Kimball
Ex-Rp Rebuttal

Rebuttal to Expert Report and Narrative Relative to Water Right Transfer #79384 for Irrigation

By: DuWayne Kimball, P.E.

Date: February 28, 2015

Expert Report Parameters
Brockway aquifer conditions

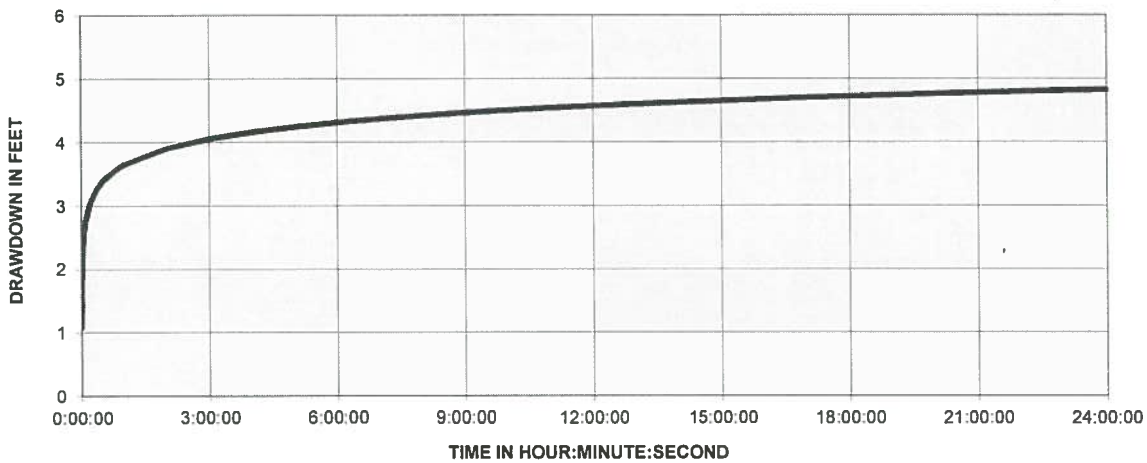
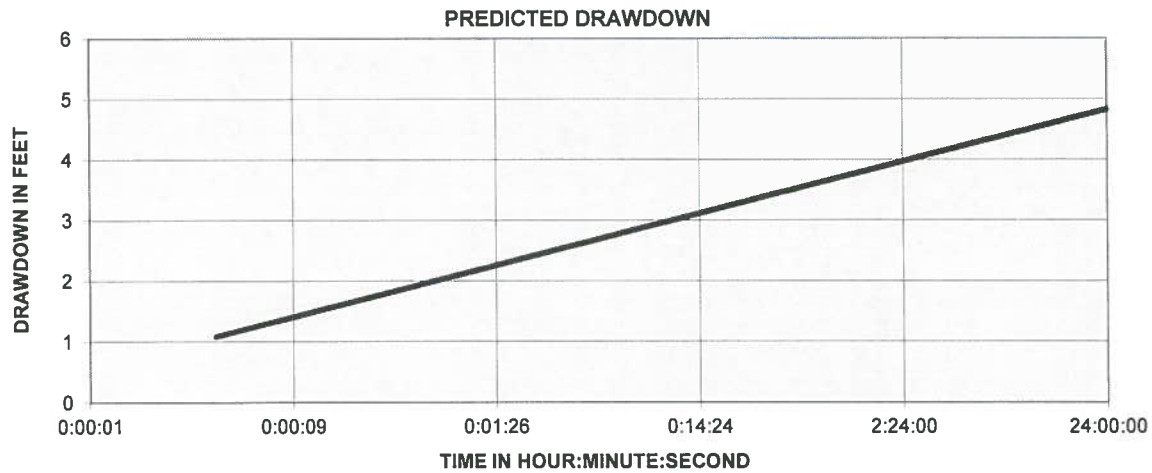
I wanted to run the experts results and my results in the Theis equation to see if the expert aquifer conditions or my aquifer conditions more closely match the actual pump test results. I set the radius at 0.5 feet which is essentially the well itself. Brockway's aquifer conditions indicate a drawdown of 4.7 feet at 16 hours into the pump test. My aquifer conditions indicate a drawdown of 88.9 feet at 16 hours into the pump test. The measured drawdown in the pump test was 153 feet.
